RESPONSE TO REQUEST FOR ADDITIONAL INFORMATION

US-APWR Design Certification

Docket No. 52-021

RAI NO.: NO. 1025-7092 REVISION 3
SRP SECTION: 03.07.02 – Seismic System Analysis
APPLICATION SECTION: 3.7.2
DATE OF RAI ISSUE: 04/29/2013

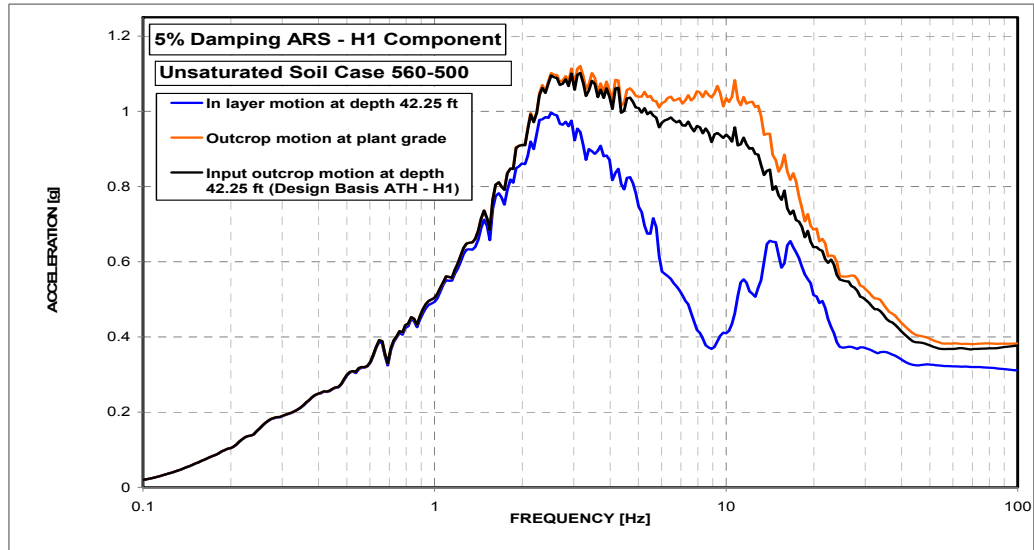
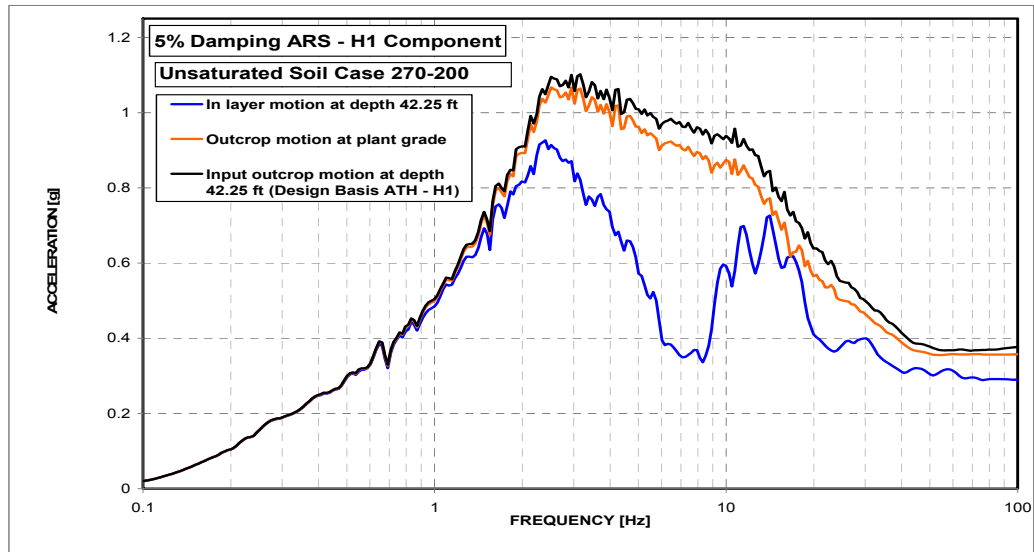
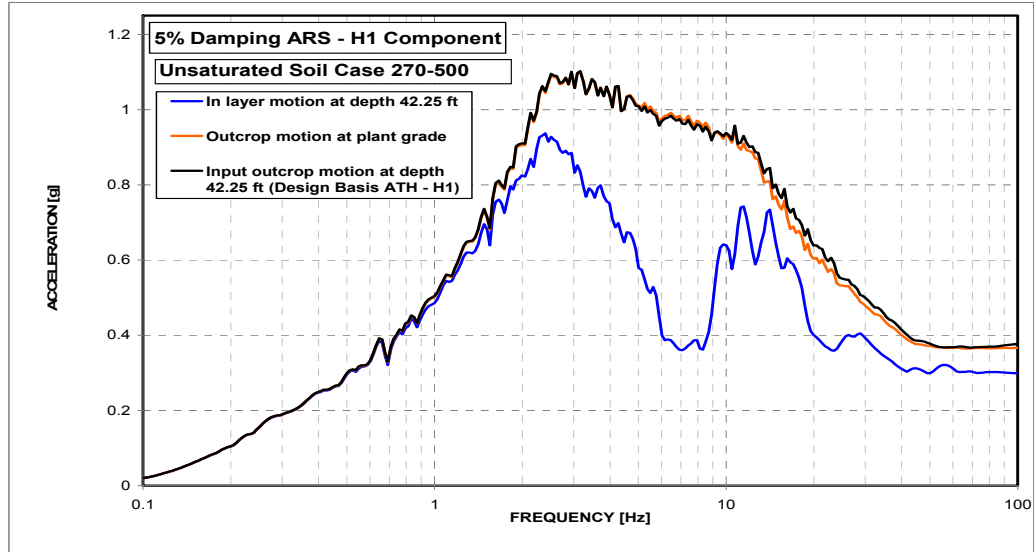
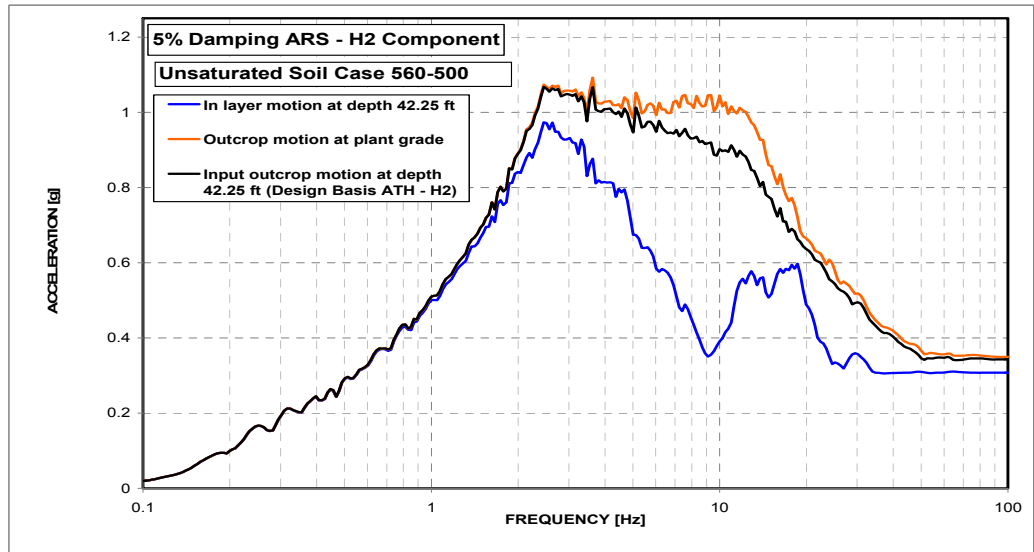
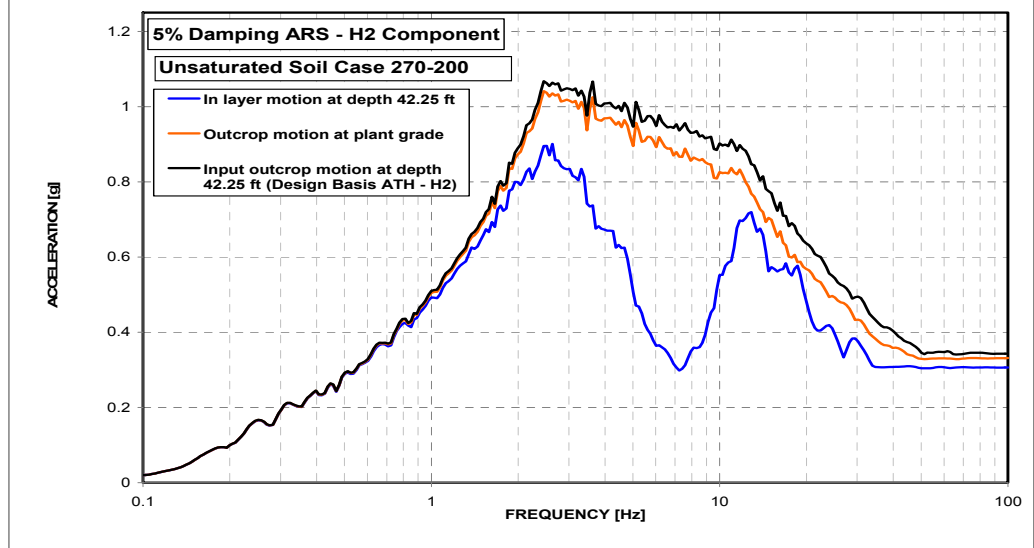
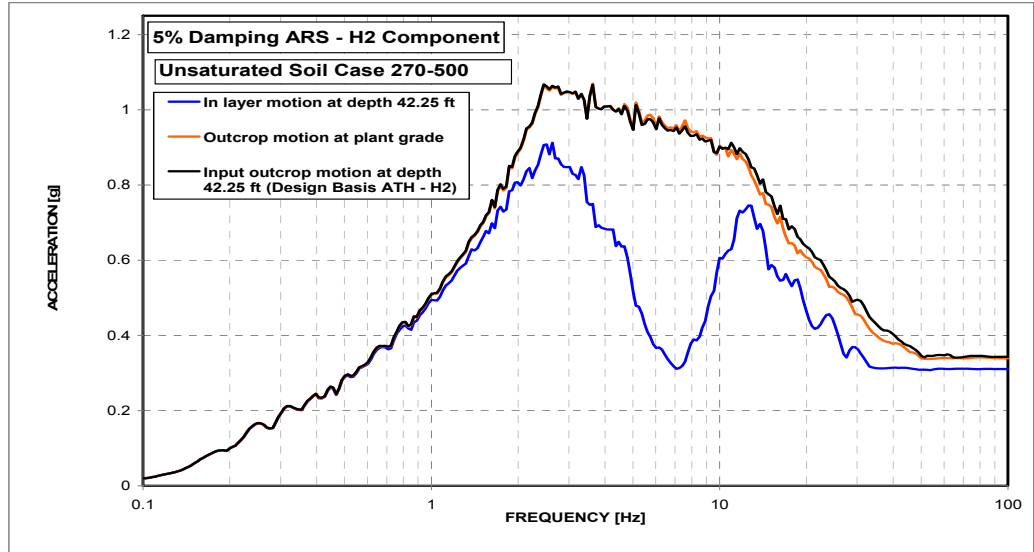
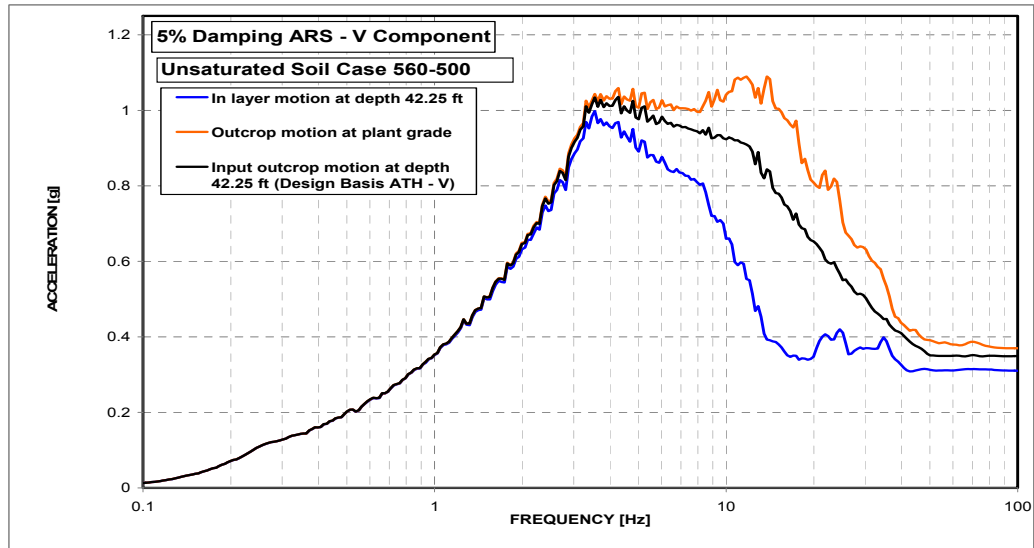
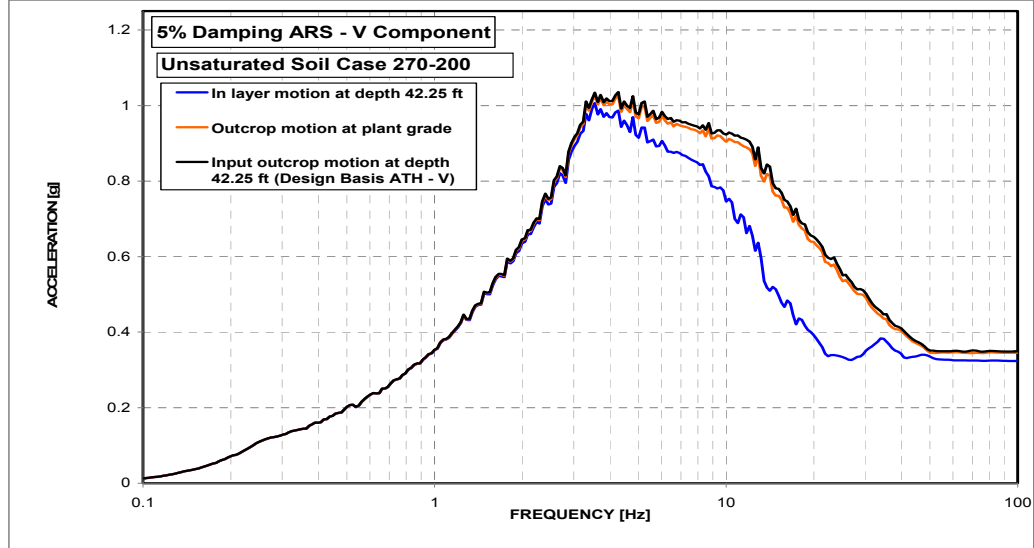
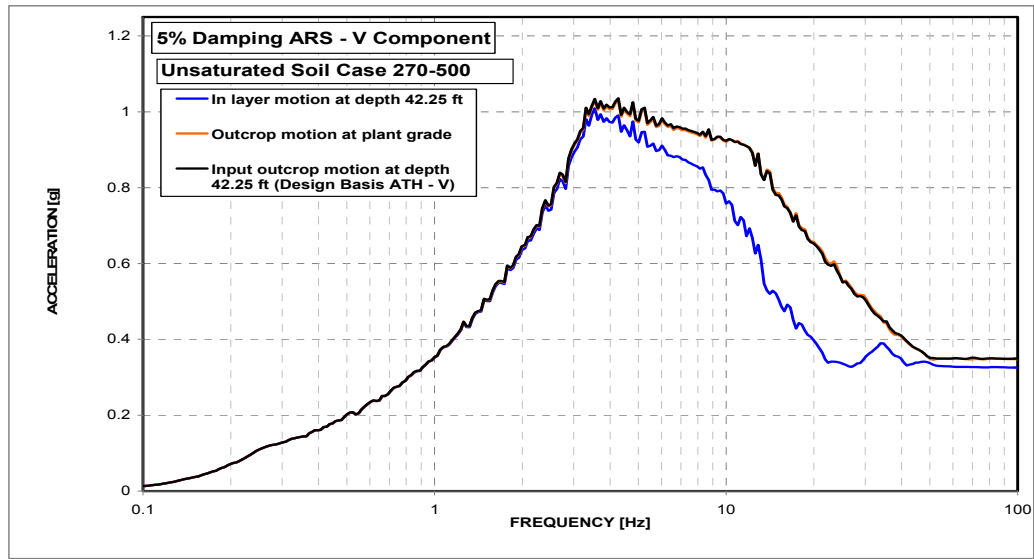
Figures 3.6, 3.7, and 3.8 in Section 3.2 of MUAP-11007 Revision 2 present comparison plots of the 5% damped acceleration response spectra (ARS) of the free-field within layer motion used as input for the soil-structure interaction (SSI) analyses of the reactor building (R/B) complex unsaturated and saturated soil profiles. It is the staff's understanding that these results are obtained from the deterministic one-dimensional site response analyses for the particular profiles discussed using as input the time history enveloping the smooth, broad banded outcrop response spectrum (enhanced RG 1.60 spectrum) defined as an outcrop spectrum at a depth of approximately 42' (Section 2.5.1). Staff notes the following from the referenced spectral plots in Figures 3.6, 3.7 and 3.8:

- a) the amplification of the smooth input outcrop motion from the foundation depth to the surface is uniform (i.e., indicates no spectral peaks) from very low frequencies to high frequencies;

- b) the de-amplification from the surface down to the foundation depth of the in-column spectra shows a major dip at the first column frequency of around 7 to 8 Hz;

- c) the magnitude of this dip is extremely large (surface S_a of about 0.90g to 0.35g at about 8 Hz for the 270-200 site), or a reduction of over 60%;

- d) no similar dip is apparent in the vertical spectra plots;
- e) the dip in the H1 (North-South) and H2 (East-West) responses are different for the same site profile;

- f) the behavior between the 270-200 and 270-500 profiles is essentially the same with an even greater difference between the H1 and H2 responses;
- g) the behavior of the 560-500 profile also shows large dips at between 7 and 10 Hz. The applicant did not provide a detailed description of how the in-column spectra at the ground surface and at 42' depth were generated from the certified seismic design response spectra (CSDRS). In order for the staff to evaluate the effects of

- (i) Reason (s) for and the design significance of the large dip between 7-10 Hz. in the horizontal in-column response spectra at the foundation depth for the three soil profiles considered for the evaluation.
- (ii) For the 270-200 soil case, for both saturated and unsaturated conditions, provide a copy of the horizontal and vertical (H1, H2 and V) time histories that were used to generate the (1) spectra at the surface and (2) in-column spectra at the 42' foundation depth, both based on the CSDRS applied at a hypothetical outcrop at the 42' foundation depth. Also, identify which records were used as input to the SSI analyses.

Any horizontal motion at the depth of the foundation (in-layer motion) must be deficient in components of the natural frequency of soil column above the depth. The corresponding in-layer motion response spectra will therefore show dips at proximity of the soil column natural frequency. The referred dips in the ARS of the horizontal in-layer motion that occur at frequencies between 7 and 10 Hz are accompanied with peaks in the transfer functions, as shown in Figures 3-9, 3-10 and 3-11 of Technical Report MUAP-11007, Rev. 2. The frequencies at the peaks approximate to the natural frequencies of the soil column above. Section 03.3.2 of Technical Report MUAP-10006, Rev. 3 addresses the significance of the dips of the in-layer response spectra on the US-APWR standard design by comparing the envelope of the in-layer motion ARS for all six generic soil profiles with the certified seismic design response spectra (CSDRS). Figure 03.3.2-1 through Figure 03.3.2-3 of Technical Report MUAP-10006, Rev. 3 show that for all three directions of the input motion there are no deep valleys in the envelopes in-layer motion ARS due to the wide range of soil properties considered in the standard design seismic response analyses.

The calculated in-layer motion acceleration time histories and the input outcrop motion design basis time histories define the design ground motion at the same horizon located 42.25 ft below the plant grade surface. The figures below present a comparison of (a) the five percent damped ARS of the design basis acceleration time histories with the ARS of the surface outcrop motion, and (b) in-layer motion used as input for the SSI analyses of the generic unsaturated soil profiles 270-200, 270-500 and 560-500. The ARS of the standard design basis motion are identical to the five percent damped ARS presented in Figures 01.5.1.2-4a, 01.5.1.2-5a, and 01.5.1.2-6a of Technical Report MUAP-10006, Rev. 3. The ARS comparisons show that the dips in the in-layer motion ARS are due to the different definitions of the two types of motion. The frequency domain solution of one-dimensional wave propagation in layered media permits the motion in each soil layer for each frequency of analysis to be decomposed into two components, an incoming (or within layer) component and a reflected component. The "outcrop" motion for each layer is defined as two times the incoming component of the motion in that layer. The boundary conditions at the surface of the soil column set the magnitudes of the in-layer and the reflected component to be equal. For soil layers below the column surface, the magnitudes of incoming and reflected components, and thus the in-layer and outcrop motion, depend on the dynamic properties of the soil above the layer.

The observed dips in the in-layer motion ARS are due to resonance effects at frequencies close to the frequency of the column of soil above the layer. The dips in the in-layer motion ARS of the two horizontal earthquake components occur at frequency of 7 Hz for the softer 270-200 and 270-500 soil profiles and 9 Hz for the harder 560-500 profile. The plots show that the differences between the two horizontal standard design basis acceleration time histories used in the site response analyses as input motion are reflected in the resulting in-layer motion ARS. The plots also show that the dips in the vertical in-layer motion ARS occur at higher frequencies reflecting that fact that the shear column frequencies are lower than the compression column frequencies.
